ADDENDUM NO. 1

Project: Clinton County Satellite Office
Dewitt Garage
IIW Project No.: 11176-06

Issue Date: Friday, January 31, 2014

2 / C6.02 DETAIL
RCP BEDDING

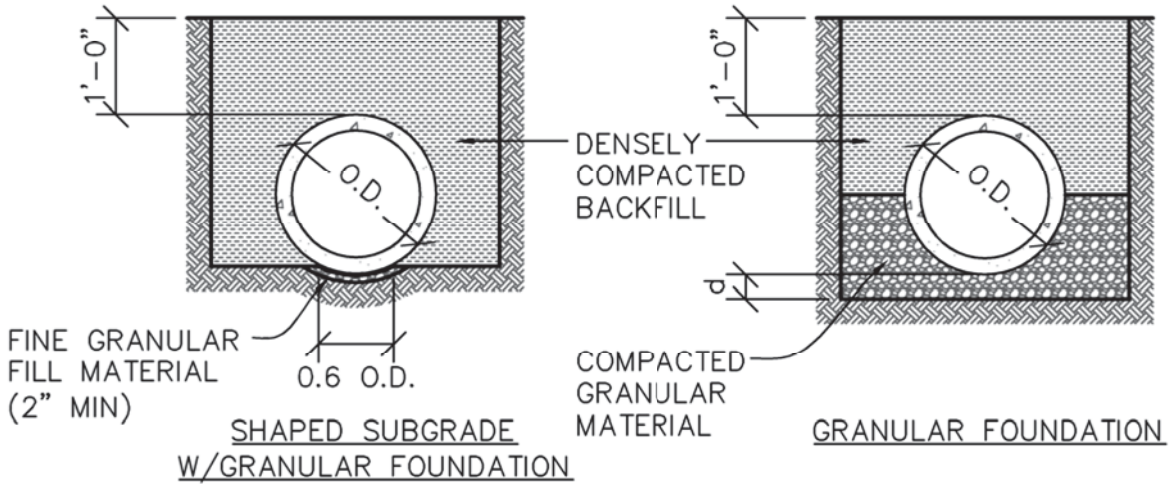
2. SHEET C6.02
   a. Detail 2: Replace with Detail 2 per Addendum Drawing C/AD1-1.
   b. Detail 3: Replace with Detail 3 per Addendum Drawing C/AD1-2.
   c. Detail 4: Replace with Detail 4 per Addendum Drawing C/AD1-2.

NOTE: FOR CLASS B BEDDINGS, SUBGRADE SHOULD BE EXCAVATED OR OVER-EXCAVATED, IF NECESSARY, SO A UNIFORM FOUNDATION FREE OF PROTRUDING ROCKS SHALL BE PROVIDED.

GENERATOR PAD

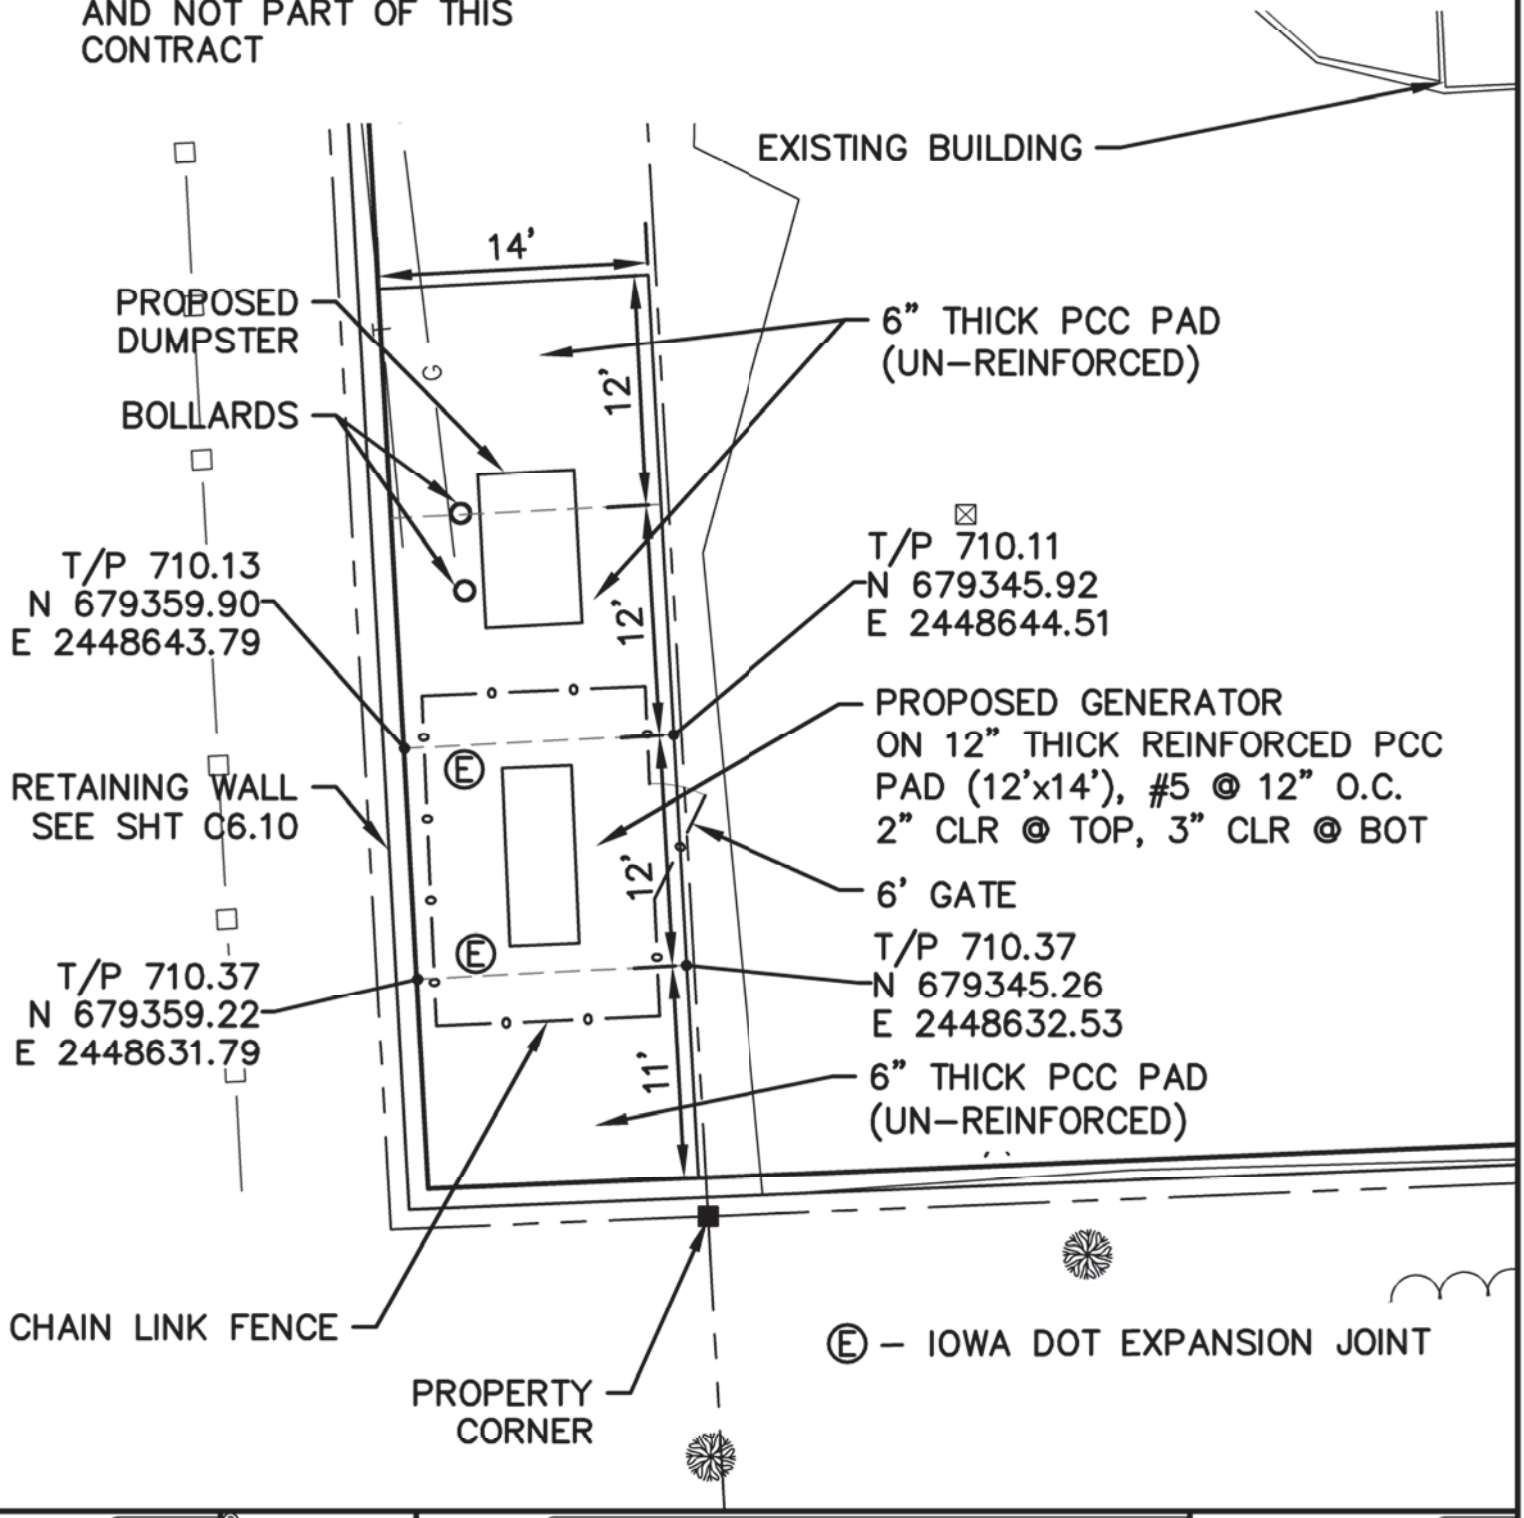
b. Refer to Addendum Drawing C/AD1-3 for modifications to generator and transformer pad information on northwest side of the site.

1. COORDINATE BOX-OUT IN PAD FOR ELECTRICAL CONDUIT WITH OWNER
2. GENERATOR AND INSTALLATION OF GENERATOR ARE BY OTHERS AND NOT PART OF THIS CONTRACT

1 CARD READER DETAIL
NO SCALE

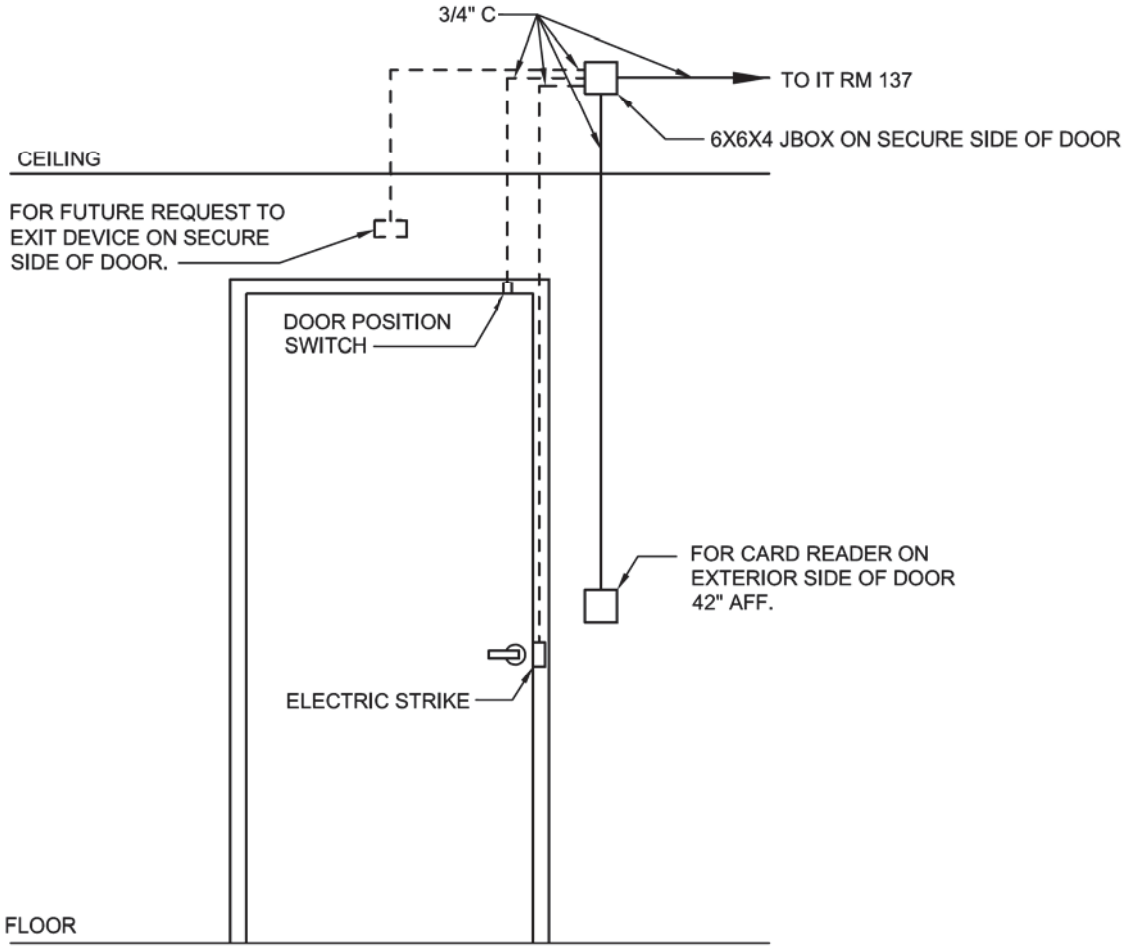
c. Electric Panel Schedule: Change mounting from "surface" to "recessed".
d. General Notes: Add Note M: "All conduit asscciated with this project shall be concealed."
e. Lighting Fixture Schedule: Add Note to Type "S" fixture: "Fixtures shall be on circuit 17 and controlled by parking lot lighting photo cell."
f. Insert Card Reader Detail per Addendum Drawing E/AD1-1.
